Access Compliance Report Public Rights-of-Way (Curb Ramps)

Main Street: ROOSEVELT_AVE Cross Street: HARPER_ST Location: NW

ADA ID: RPRK211001135928 Ramp Type: Type 1 - Perpendicular Diagonal Initial Pass/Fail: Pass Overall Compliance: No Severity Score: 10

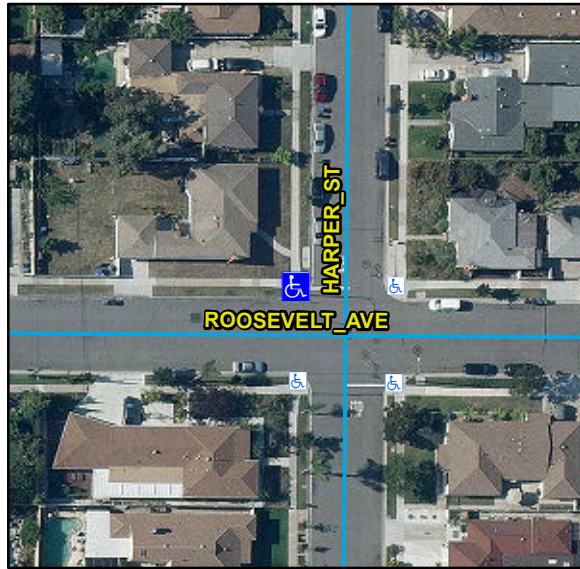
R304.2.2, R304.2.1, R304.2.2-Perp, R304.3.2-Para, R304.5.3, STD 1115

Remove & Replace Curb Ramp With Two New Directional Ramps or Equivalent.
